Title - Sujet Food Service Bldg Westmorland Inst	
Solicitation No. - N° de l'invitation EC016-141832/A	Amendment No. - N° modif. 003
Client Reference No. - N° de référence du client EC016-141832	Date 2014-01-17
GETS Reference No. - N° de référence de SEAG PW-\$PWB-020-3350	
File No. - N° de dossier PWB-3-36100 (020)	CCC No./N° CCC - FMS No./N° VME
Solicitation Closes - L'invitation prend fin at - à 02:00 PM on - le 2014-01-23	Time Zone Fuseau horaire Atlantic Standard Time AST
F.O.B. - F.A.B. Plant-Usine: <input type="checkbox"/> Destination: <input type="checkbox"/> Other-Autre: <input type="checkbox"/>	
Address Enquiries to: - Adresser toutes questions à: Donovan, Janine PWB	Buyer Id - Id de l'acheteur pwb020
Telephone No. - N° de téléphone (506) 636-5347 ()	FAX No. - N° de FAX (506) 636-4376
Destination - of Goods, Services, and Construction: Destination - des biens, services et construction:

This Tender Amendment No. Three (3) is raised to include the following Addendum No. Three (3).

Addendum No. 3

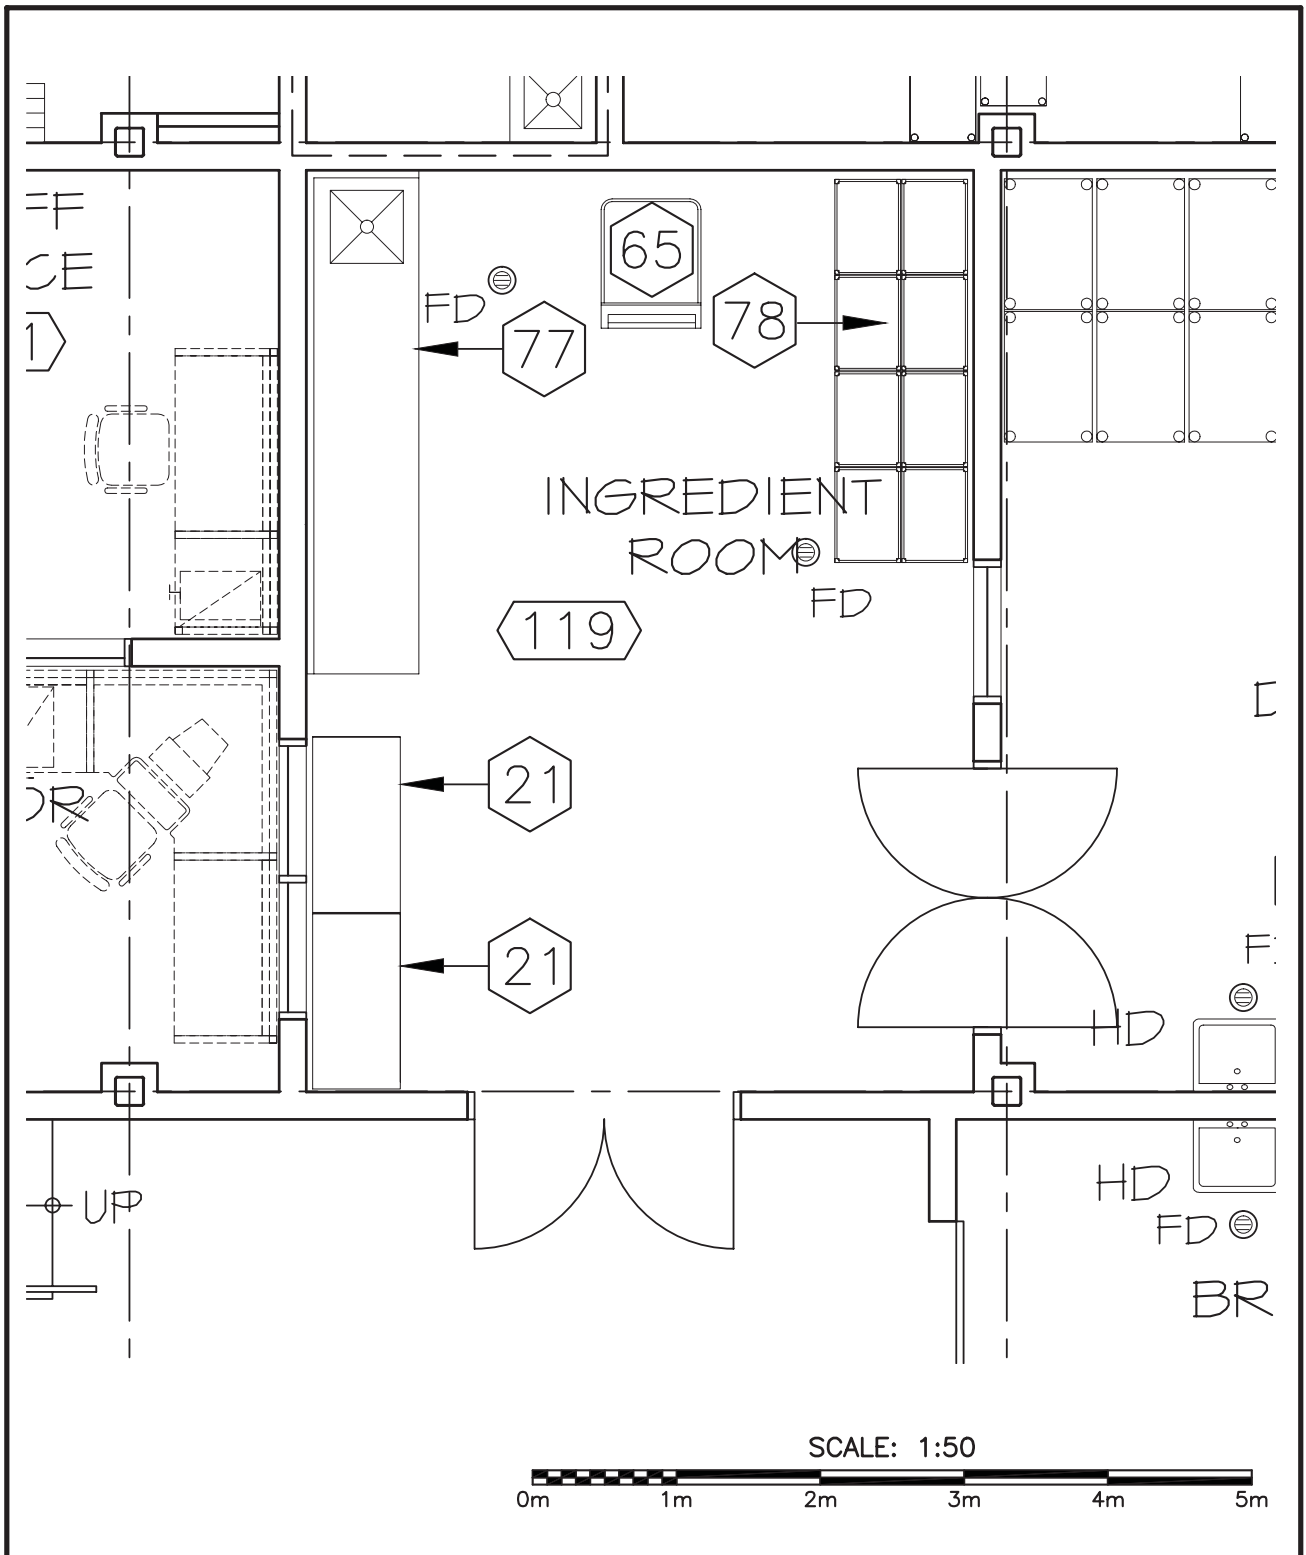
1. **Drawing FS.1 - Ground Floor Equipment Layout and Section 11 40 20 - Food Service Custom Equipment.**
 1. Room (122) Breakdown Area:
Delete three (3) equipment item # 21 worktables, shown along wall on gridline D.
 2. Room (119) Ingredient Room - refer to sketch FS SK-02 (attached):
 1. Delete one (1) equipment item # 21 - worktable on east wall of room, and extend length of equipment item # 77 - stainless steel worktable to 3500mm.

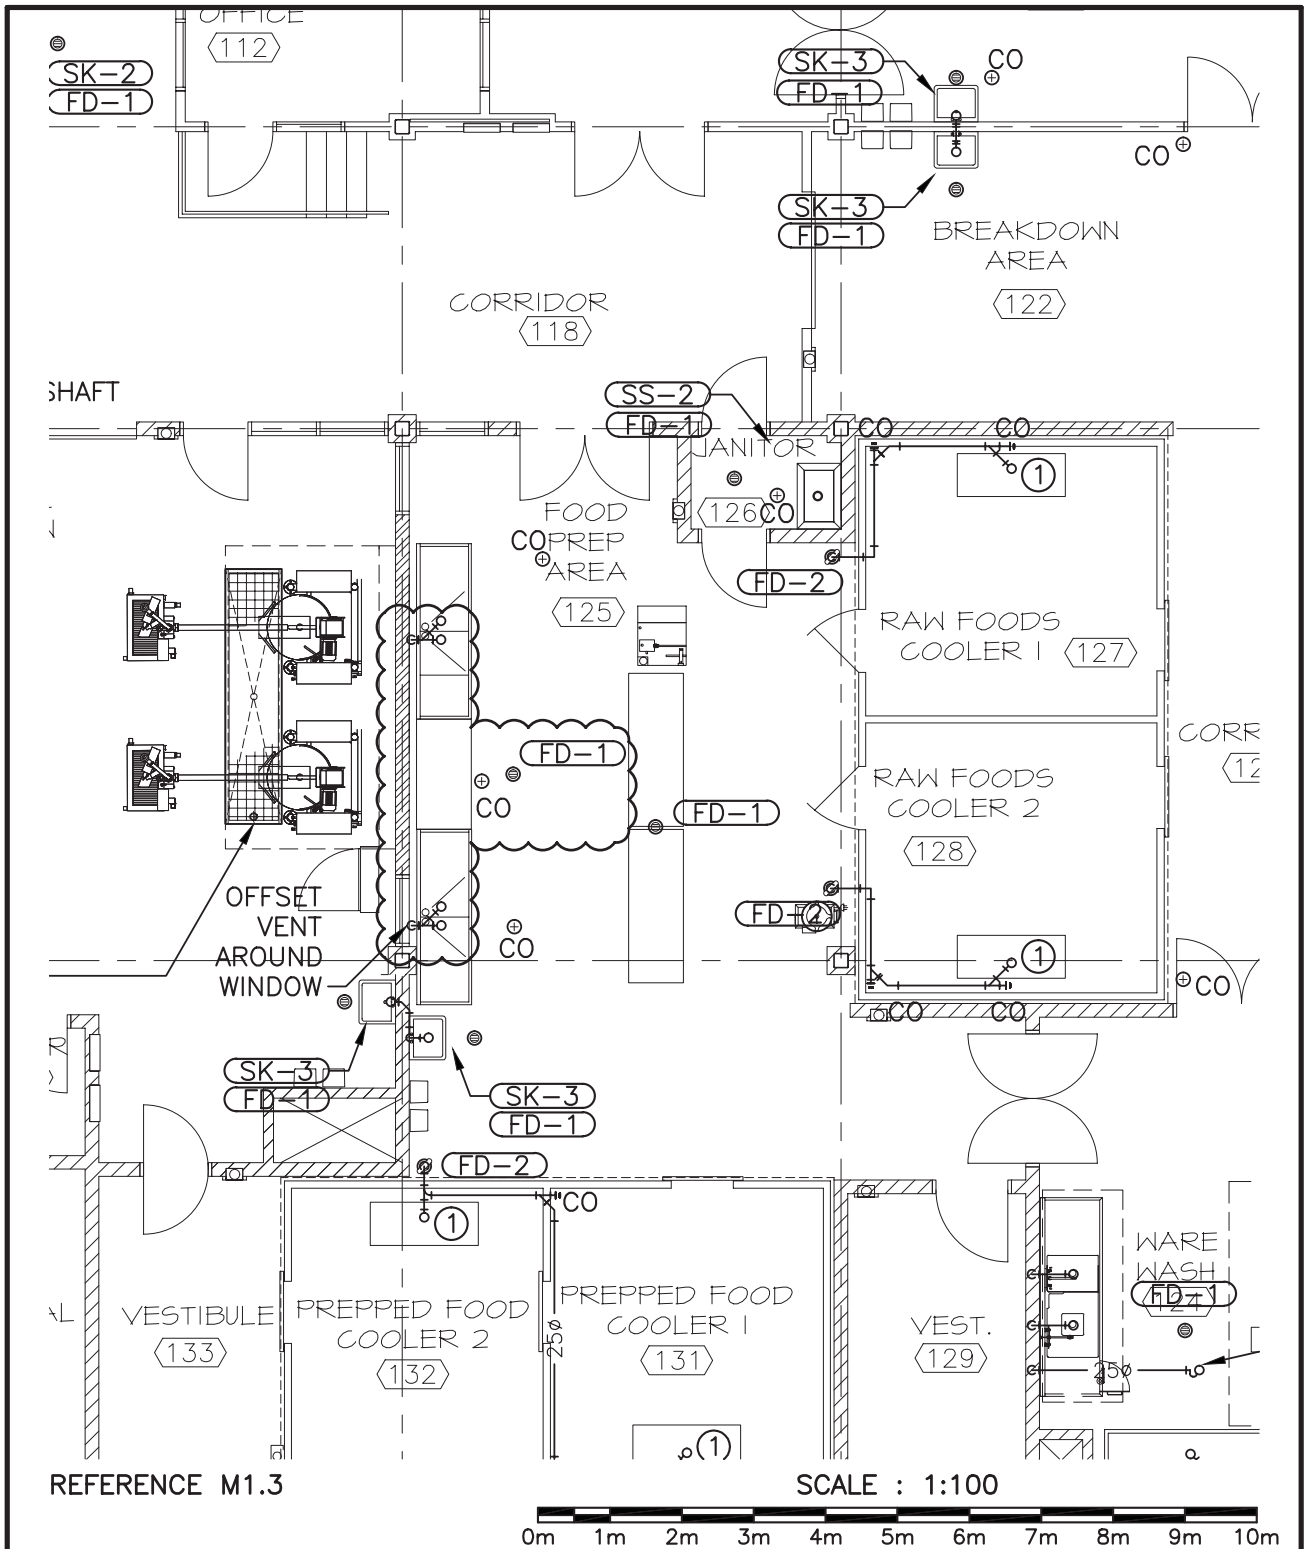
1. Provide sanitary piping and relocated floor drain for new kitchen equipment sink as indicated on attached MSK-3.

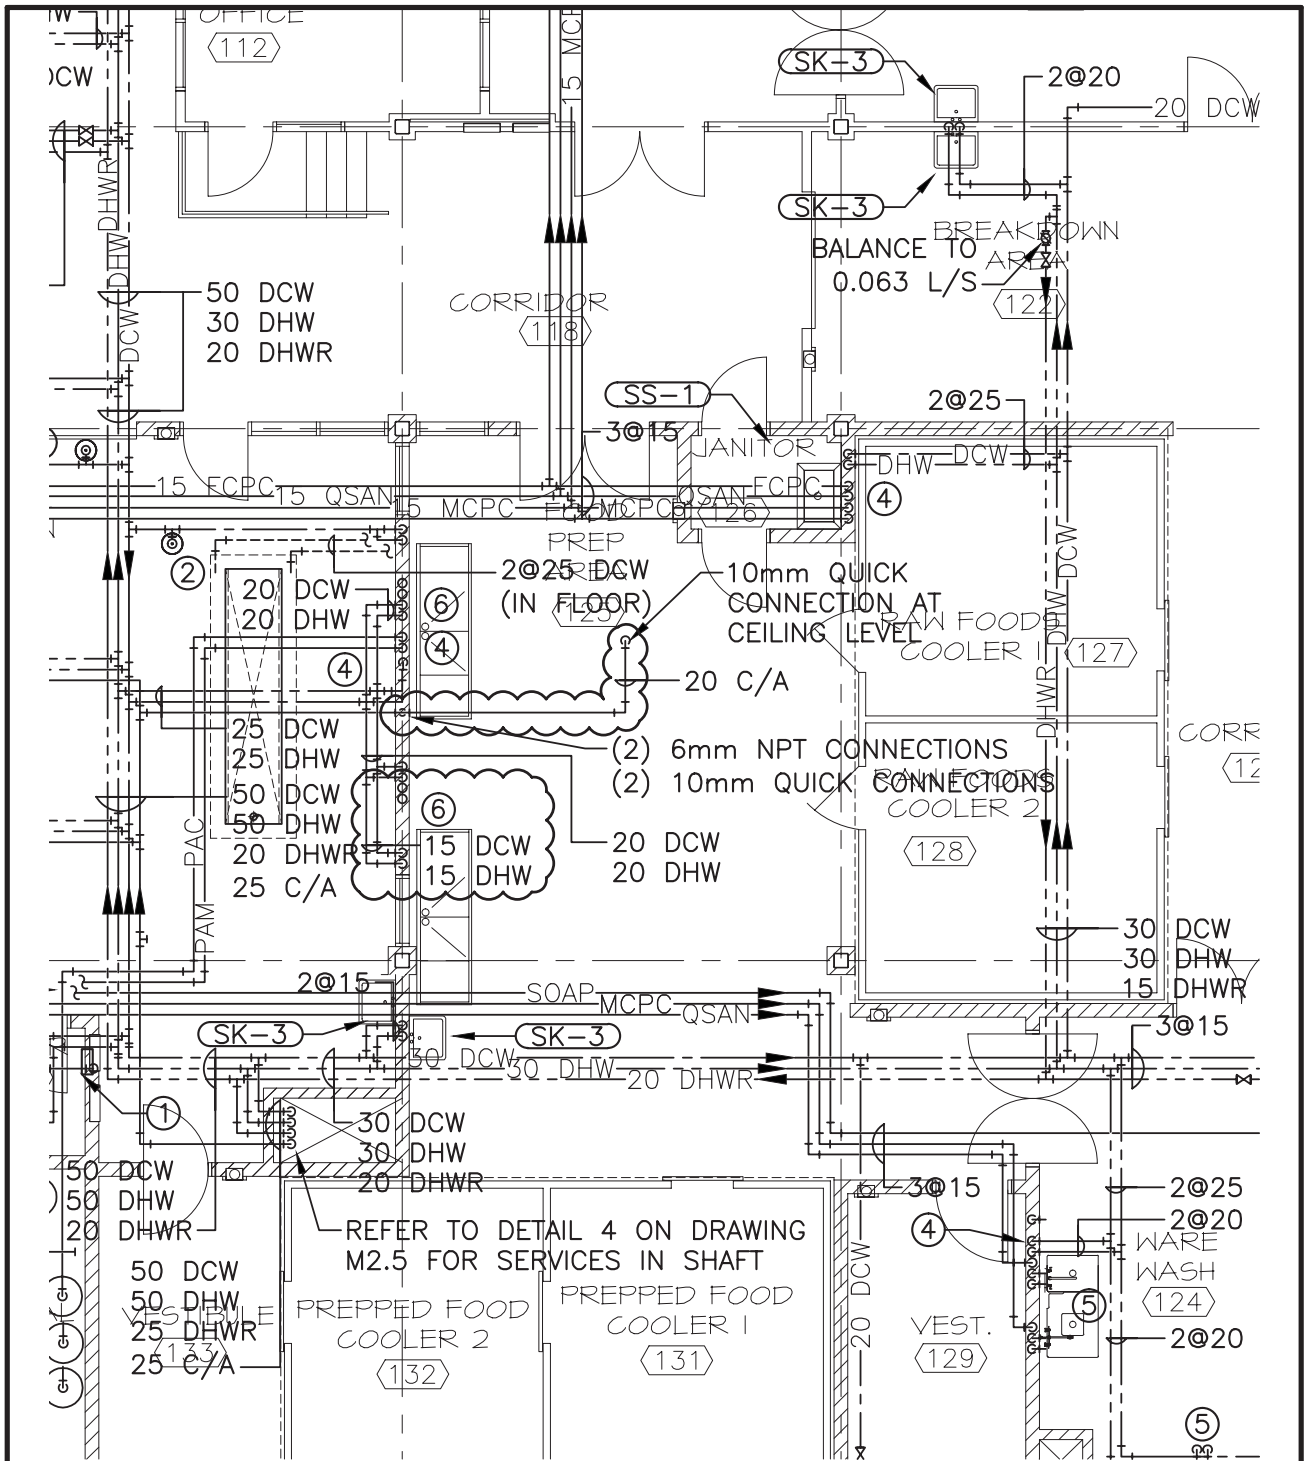
1. Provide water service to new kitchen equipment sink as indicated on attached MSK-4.
2. Revise compressed air as indicated on attached MSK-4.
3. Add plumbing for chemicals as indicated on attached MSK-1.
